# Access Compliance Report

## Public Rights-of-Way

### (Curb Ramps)

Intersection ID: 48304	Main Street: FAZENDA_DR	Cross Street: GANSO_LN	Location:	N
ADA ID: D186696020EE	Ramp Type: PerpDiag	Initial Pass/Fail: Fail	Overall Compliance: No	Severity Score: 25
Codes/Mitigation Info/Possible Solution		Field Measurements/Component Compliance

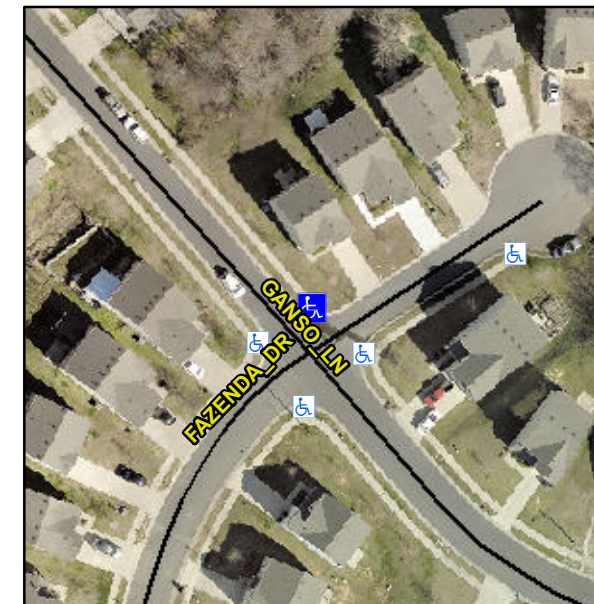
**Not Found, R304.5.3**

Compliance	Description	Data	Compliance	Description	Data
N/A	Ramp Length (in)	51.0	Yes	Ramp Slope (%)	7.2
Yes	Ramp Width (in)	48.0	No	Ramp XSlope (%)	7.9
N/A	Flare Type LT	N/A	N/A	Flare Type RT	N/A
N/A	Flare Slope LT (%)	N/A	N/A	Flare Slope RT (%)	N/A
N/A	Flare Traversable LT?	N/A	N/A	Flare Traversable RT?	N/A
N/A	Landing Length (in)	N/A	N/A	DWS Provided?	N/A
N/A	Landing Width (in)	N/A	N/A	DWS Contrast?	N/A
N/A	Landing Slope (%)	N/A	N/A	DWS Length (in)	N/A
N/A	Landing X Slope (%)	N/A	N/A	DWS Full Width?	N/A
N/A	Landing Curb? (Y/N)	N/A	N/A	DWS Offset (in)	N/A
N/A	Shared Landing?	N/A			
N/A	Gutter Ponding?	N/A	N/A	Gutter Slope (%)	N/A
N/A	Gutter Lip Ht (in)	N/A	N/A	Gutter X Slope (%)	N/A
N/A	Painted X Walk1?	No	N/A	Painted X Walk2?	No
	X Walk 1 Direction	To SW		X Walk 2 Direction	To SE
N/A	X Walk 1 Width (in)	N/A	N/A	X Walk 2 Width (in)	N/A
	X Walk 1 Slope (%)	0.7		X Walk 2 Slope (%)	7.3
	X Walk 1 X Slope (%)	9.6		X Walk 2 X Slope (%)	2.0

N/A	Ramp inside XWalk1?	N/A	N/A	Ramp inside XWalk2?	N/A
	Road Slope (%)	6.3	N/A	Clear Space?	N/A
	Road X Slope (%)	3.9	N/A	Clear Space to XWalk (in)	N/A
N/A	Any Obstructions?	N/A	N/A	Storm Grate/Utility Hazard?	N/A
	Obstruction Type			Storm Grate/Utility Type	
		N/A			N/A
			Yes	Surface Condition? (G/P)	Good

**Remove & Replace Curb Ramp With Two New Directional Ramps or Equivalent.**
